# Access Compliance Report

## Public Rights-of-Way

Intersection ID: 30490	Main Street: BRAMWYCK_DR	Cross Street: QUAIL_PARK_DR	Location: SE
ADA ID: 245CE9889384	Ramp Type: PerpDiag	Initial Pass/Fail: Fail	Overall Compliance: No
Severity Score: 21.25			
Codes/Mitigation Info/Possible Solution		Field Measurements/Component Compliance

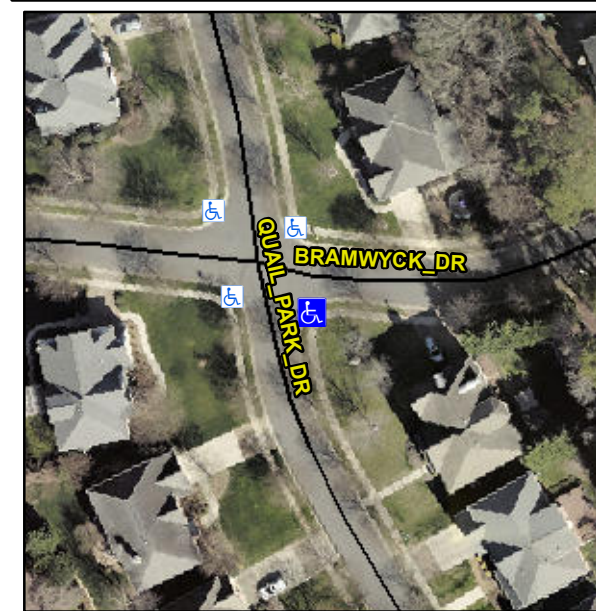
**Not Found, R304.5.1, R304.5.3**

Compliance	Description	Data	Compliance	Description	Data
N/A	Ramp Length (in)	47.5	Yes	Ramp Slope (%)	7.1
No	Ramp Width (in)	43.5	No	Ramp XSlope (%)	5.7
N/A	Flare Type LT	N/A	N/A	Flare Type RT	N/A
N/A	Flare Slope LT (%)	N/A	N/A	Flare Slope RT (%)	N/A
N/A	Flare Traversable LT?	N/A	N/A	Flare Traversable RT?	N/A
N/A	Landing Length (in)	N/A	N/A	DWS Provided?	N/A
N/A	Landing Width (in)	N/A	N/A	DWS Contrast?	N/A
N/A	Landing Slope (%)	N/A	N/A	DWS Length (in)	N/A
N/A	Landing X Slope (%)	N/A	N/A	DWS Full Width?	N/A
N/A	Landing Curb? (Y/N)	N/A	N/A	DWS Offset (in)	N/A
N/A	Shared Landing?	N/A			
N/A	Gutter Ponding?	N/A	N/A	Gutter Slope (%)	N/A
N/A	Gutter Lip Ht (in)	N/A	N/A	Gutter X Slope (%)	N/A
N/A	Painted X Walk1?	No	N/A	Painted X Walk2?	No
	X Walk 1 Direction	To N		X Walk 2 Direction	To NW
N/A	X Walk 1 Width (in)	N/A	N/A	X Walk 2 Width (in)	N/A
	X Walk 1 Slope (%)	0.2		X Walk 2 Slope (%)	2.6
	X Walk 1 X Slope (%)	4.4		X Walk 2 X Slope (%)	4.2

**Remove & Replace Curb Ramp With Two New Directional Ramps or Equivalent.**
